**ADDENDUM  
NO. 03**

**May 22, 2026**

**Kalamazoo Public Schools EL SOL School  
1428 Baker Drive  
Kalamazoo, MI 49048**

This Addendum consists of Pages ADD 3-1 through ADD 3-3 and TowerPinkster Addendum No. 03, dated May 21, 2026, consisting of 5 pages, additional Specification Section 07 21 00 Thermal Insulation, and 20 drawings.

SHEET NUMBER  
**E 201D**  
 23-622.000

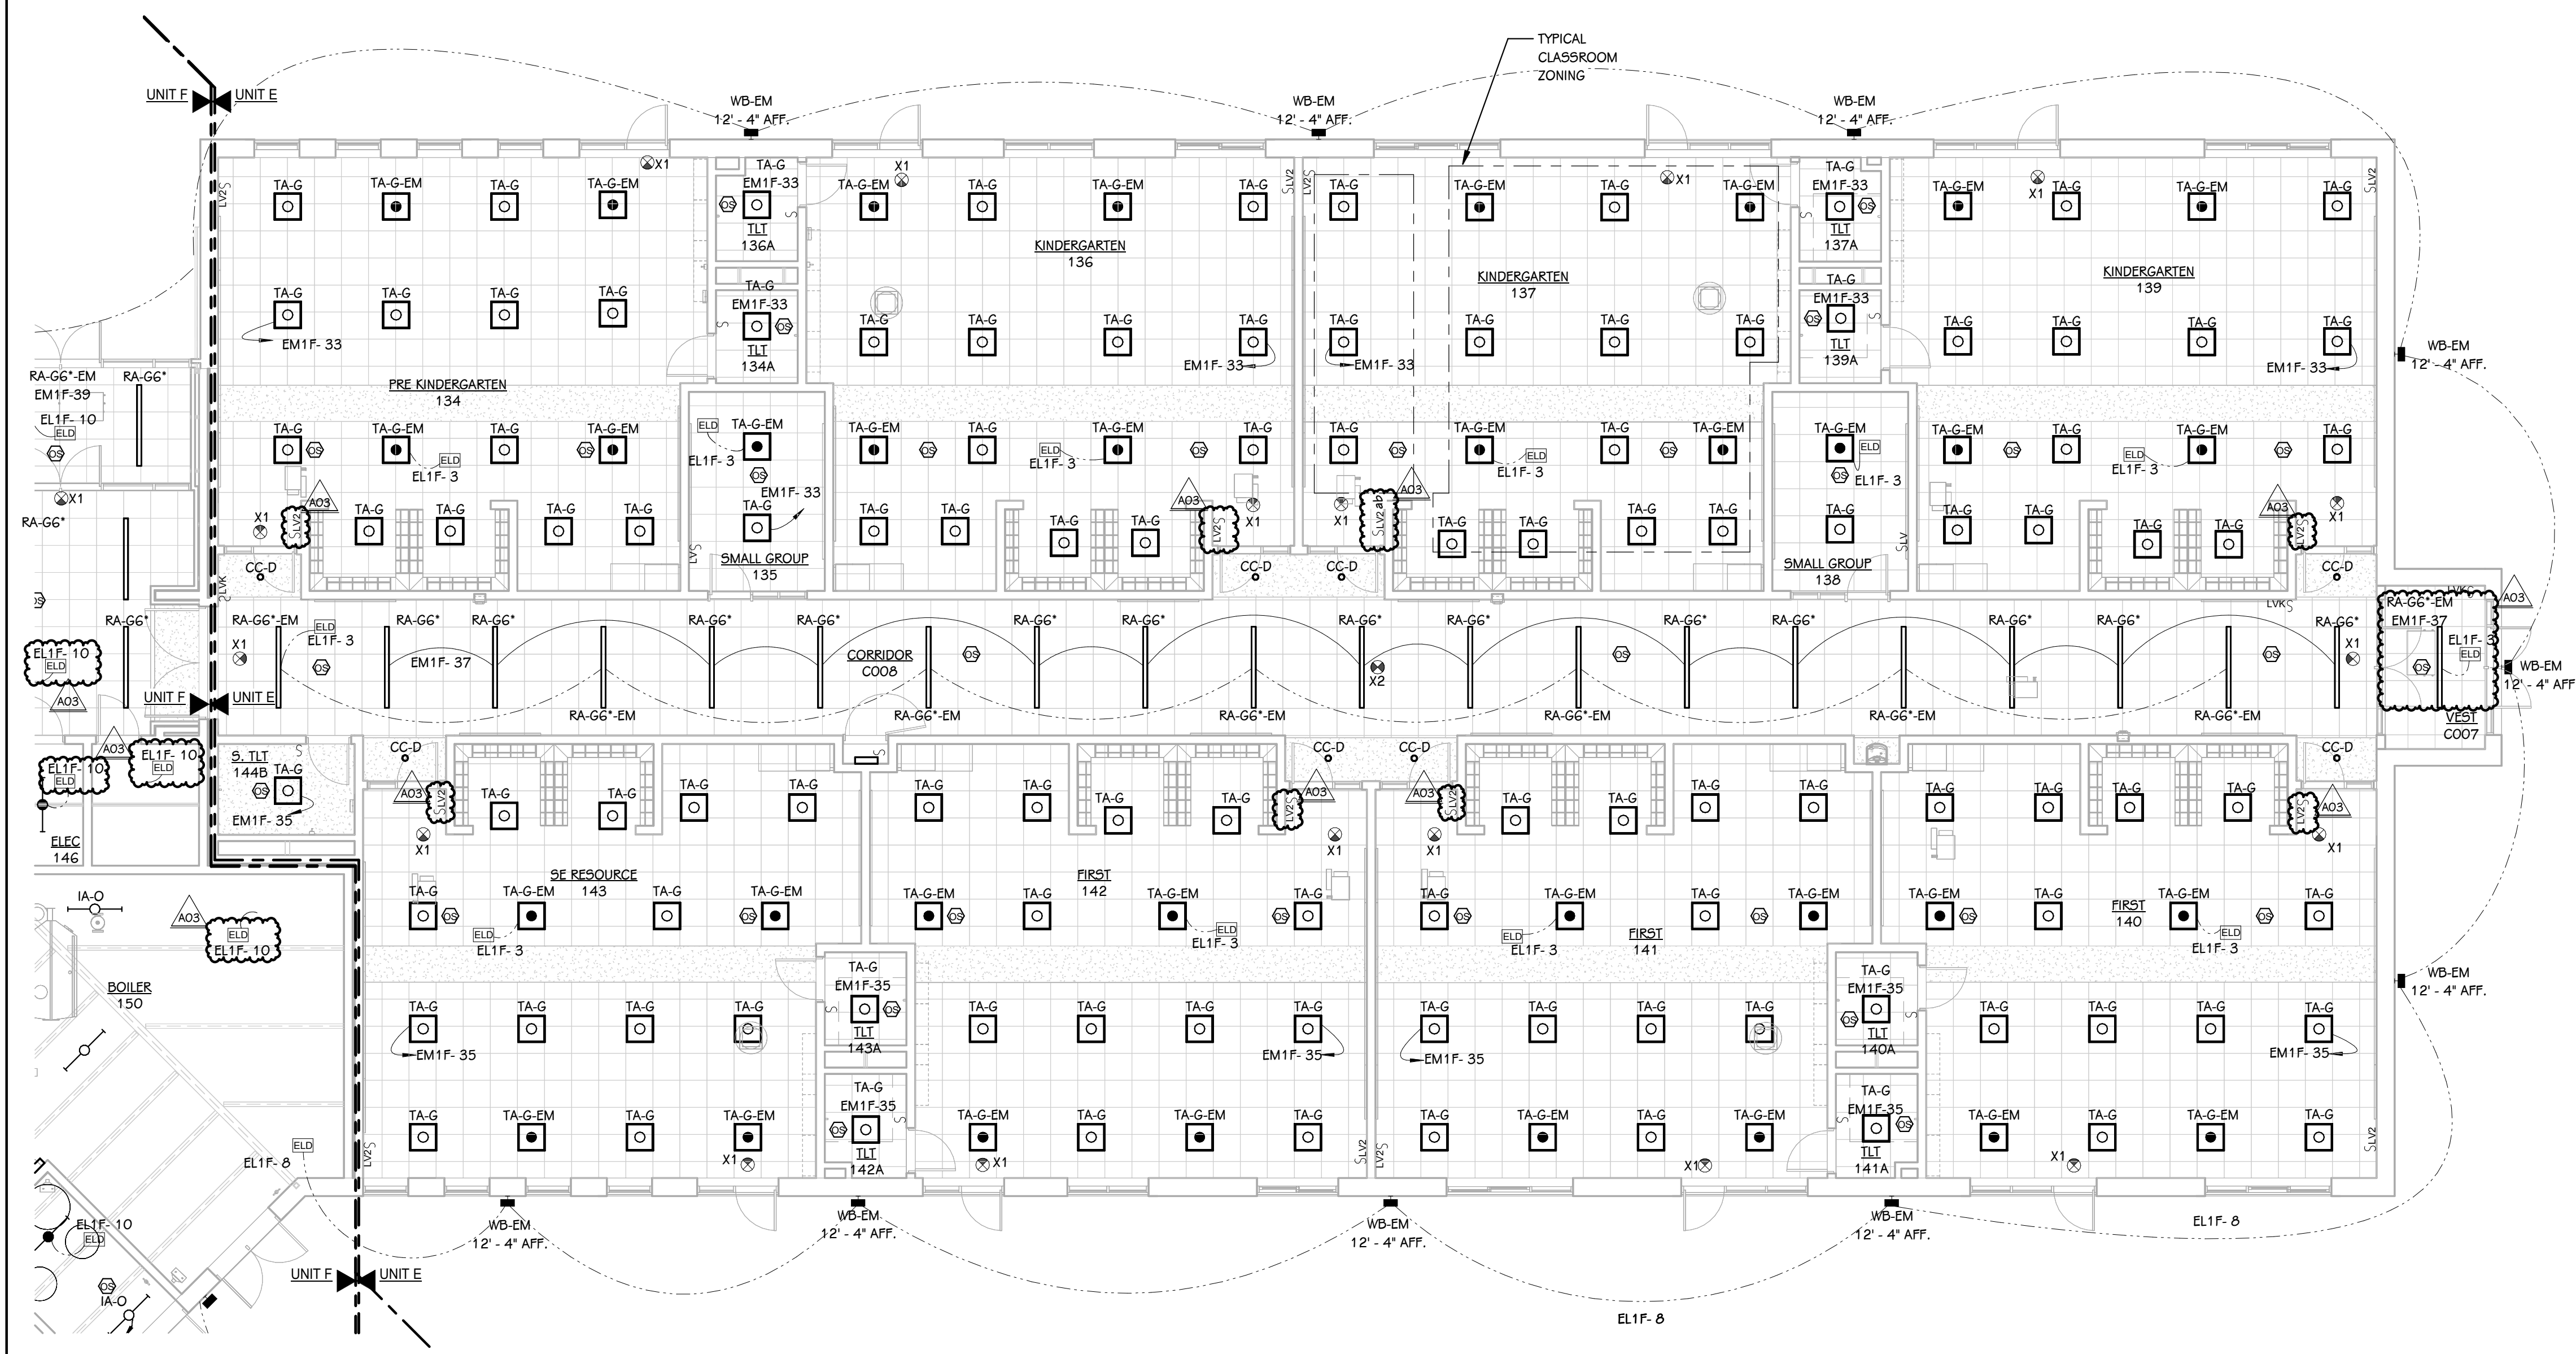
Added lines to indicate zoning. Revised EM lighting locations and associated ELDs.

Added switches to gym. Added gym equipment control detail.

SHEET TITLE  
 FIRST FLOOR LIGHTING PLAN - UNIT F

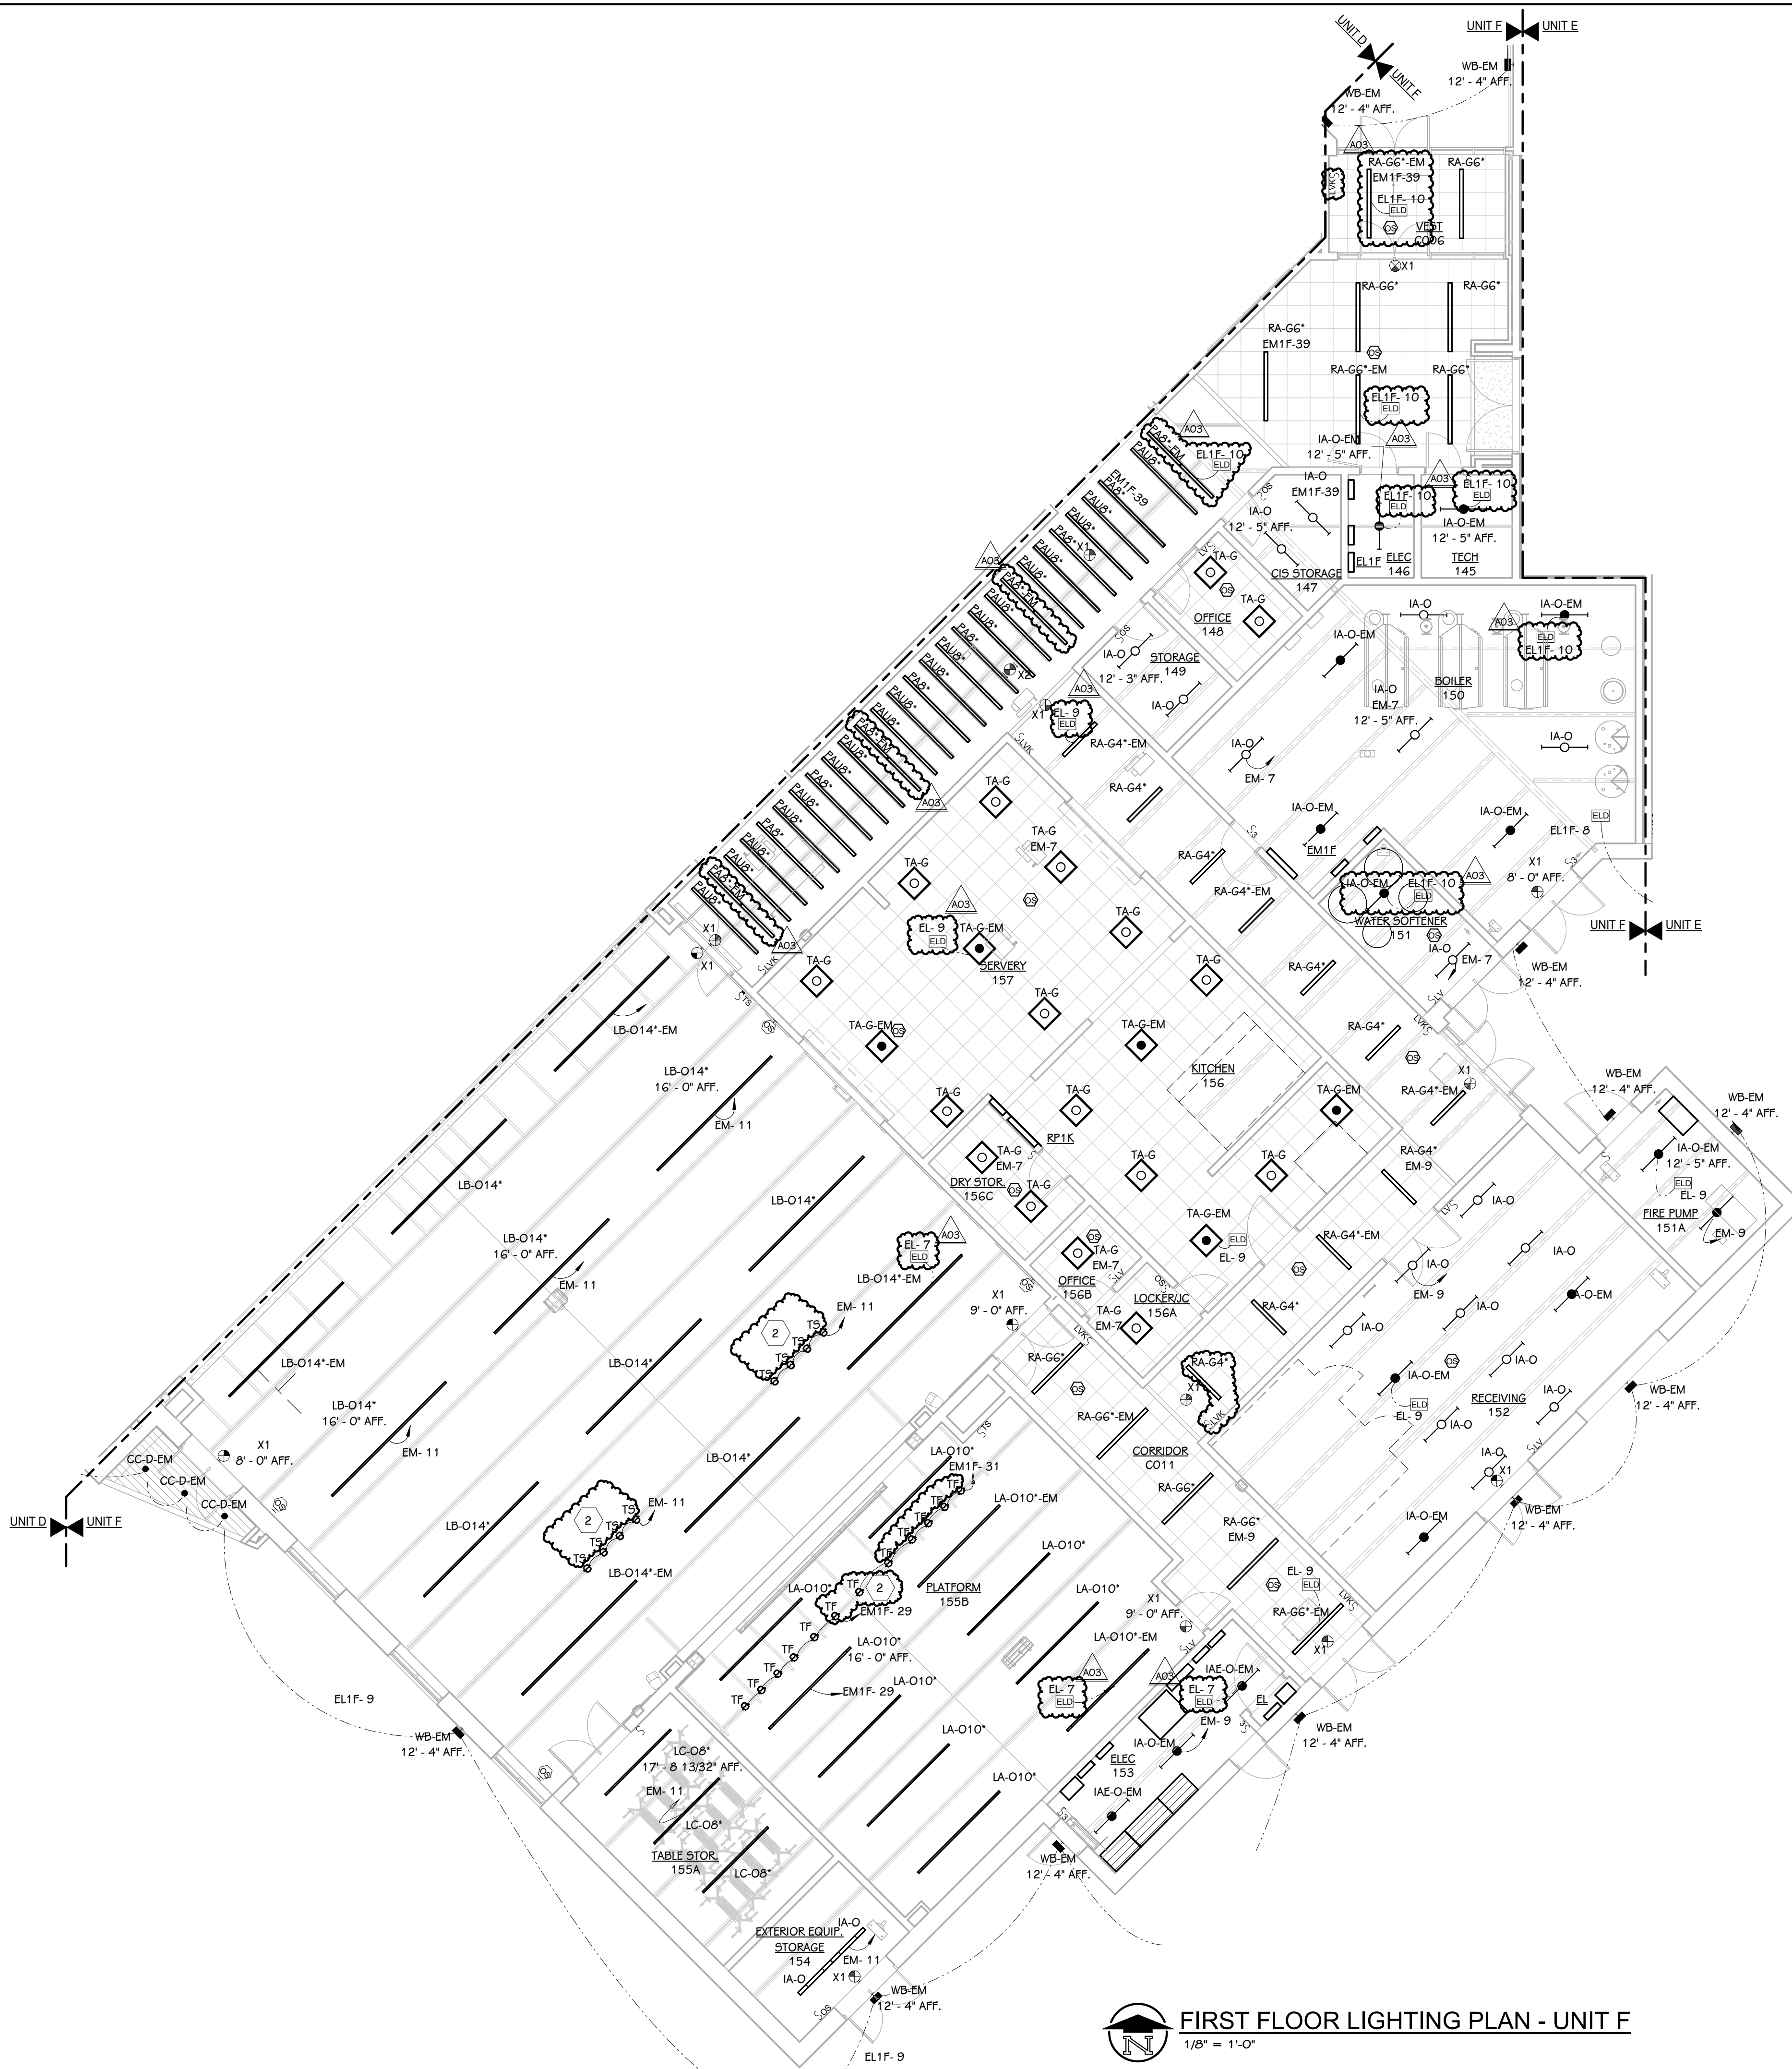
Revise track lighting to theatrical lighting in cafeteria and platform. Added keynote #2.

Add light and switch in corridor C011. Revise location of exit sign (not clouded).

SHEET TITLE  
SECOND FLOOR LIGHTING PLAN - UNIT B

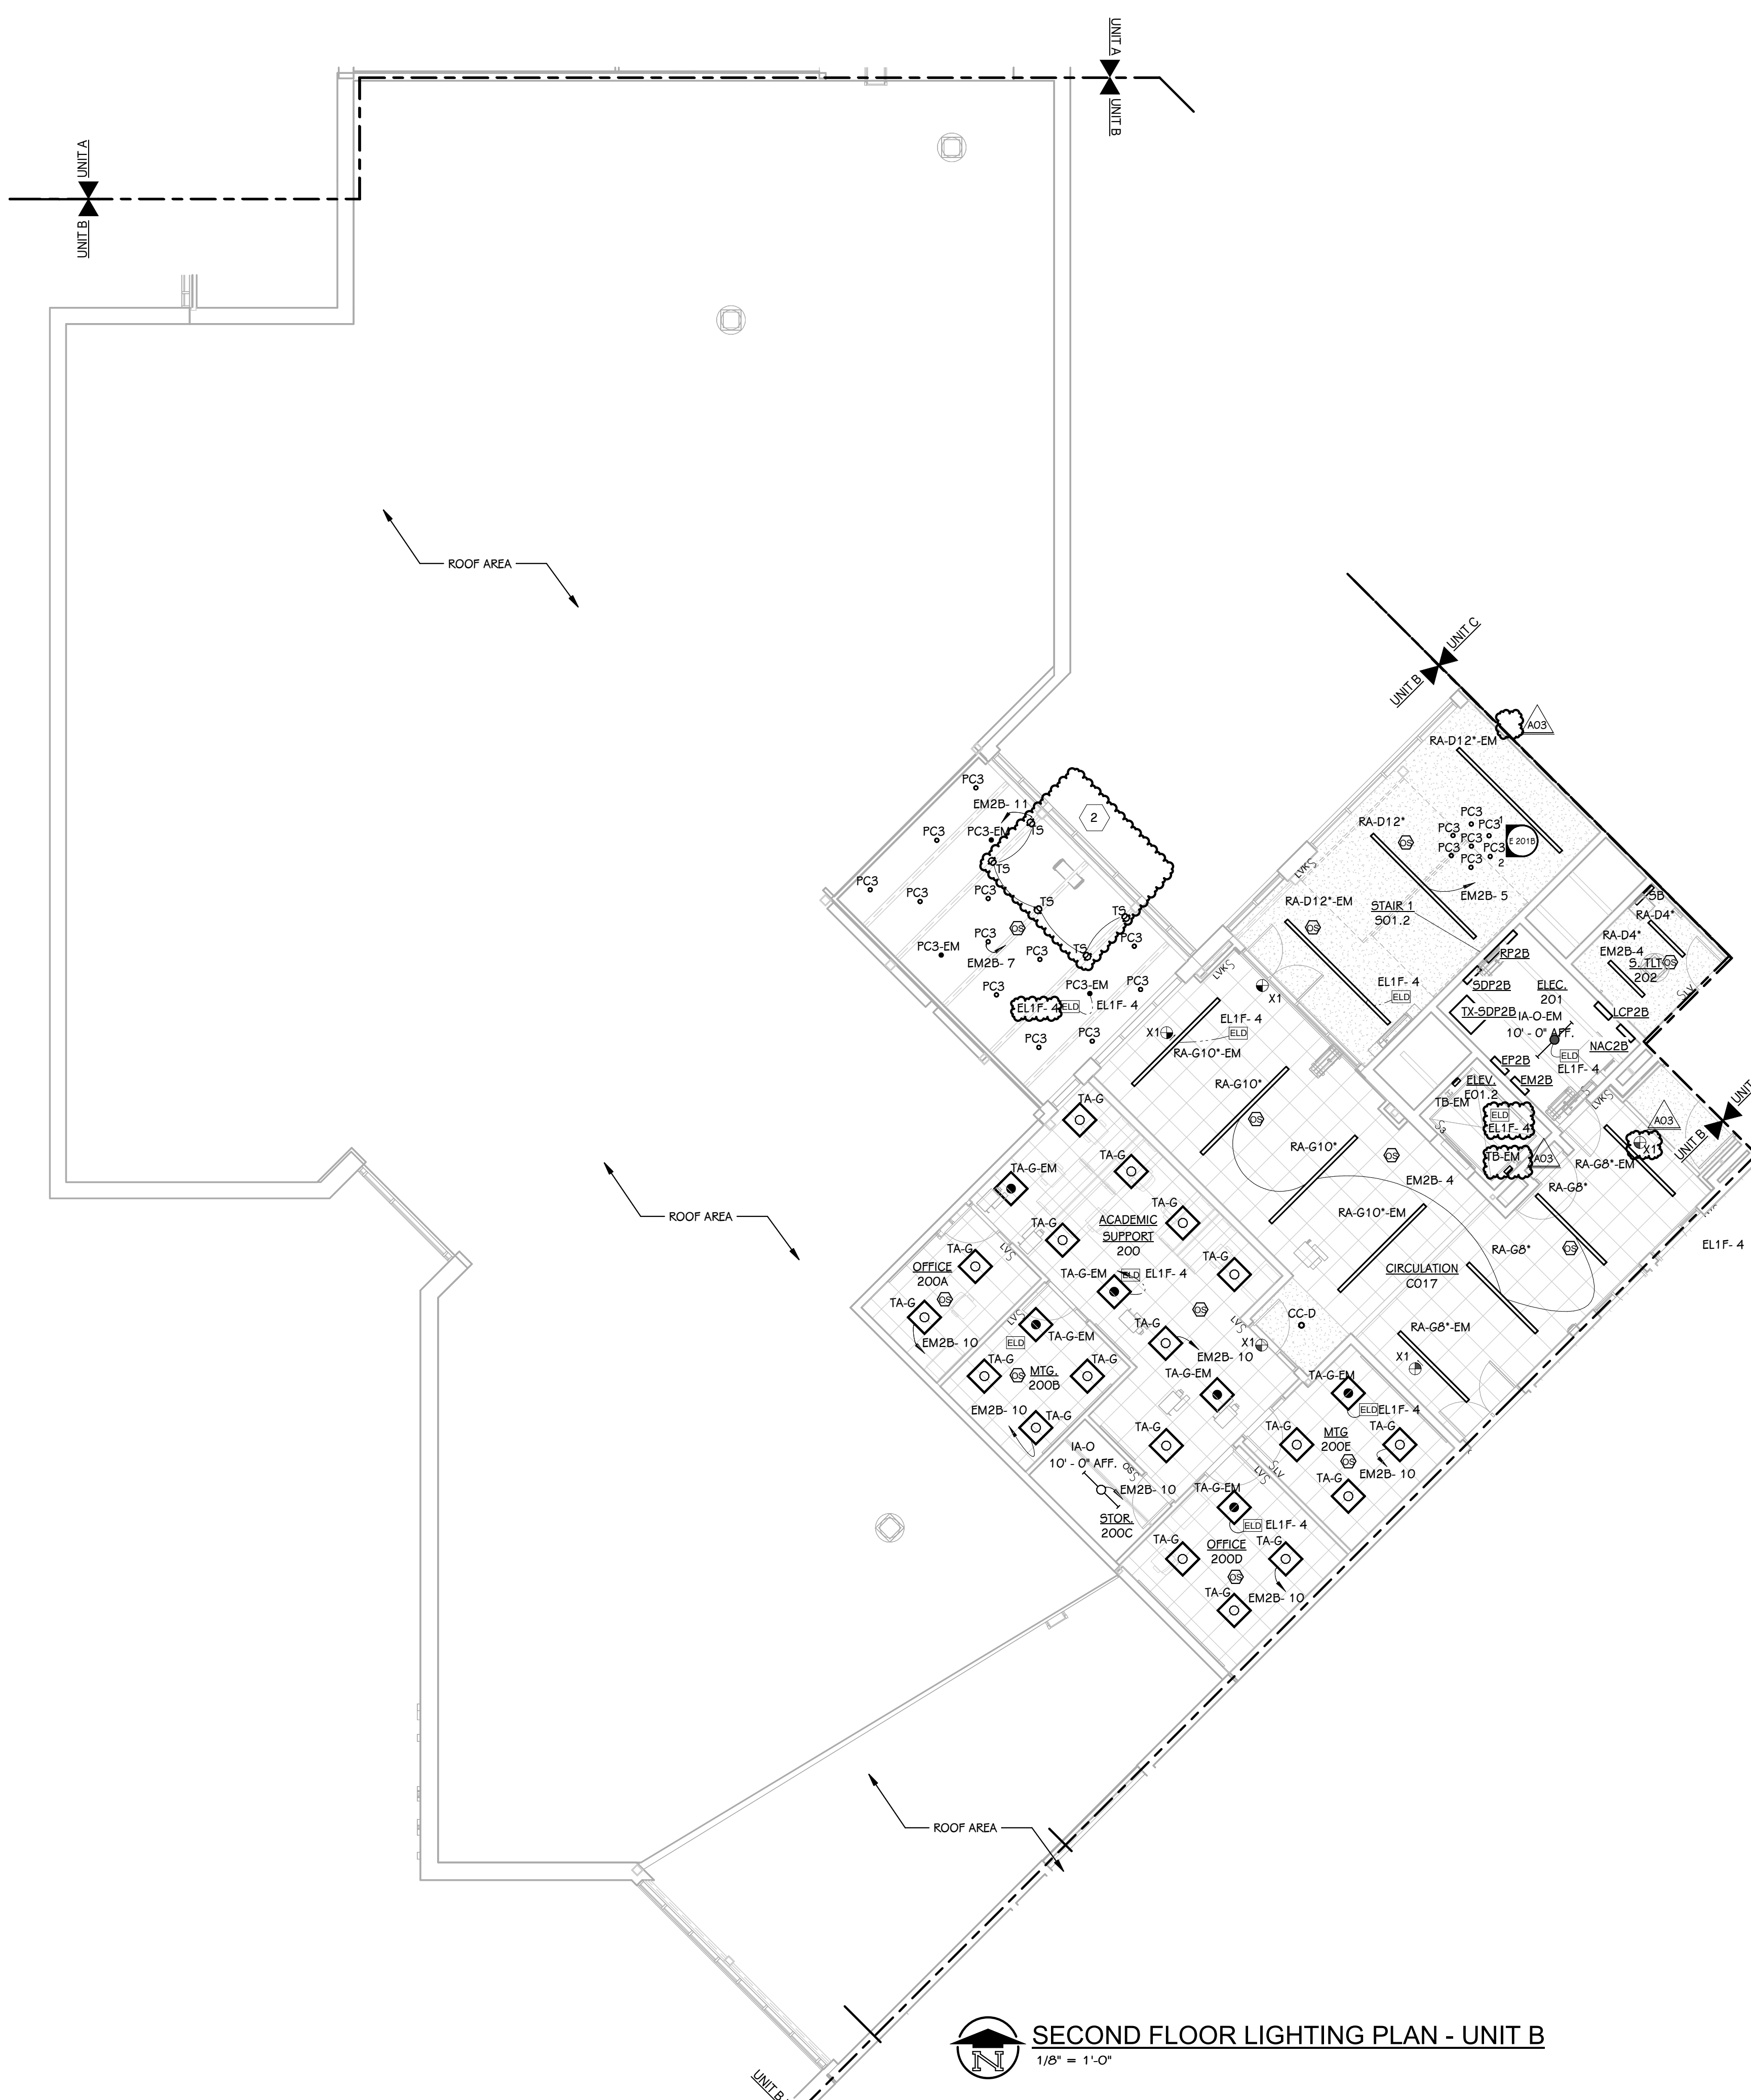
Added touch screen to statue plaza and lighting keynote #2. Revised track fixture to theatrical lighting fixture.
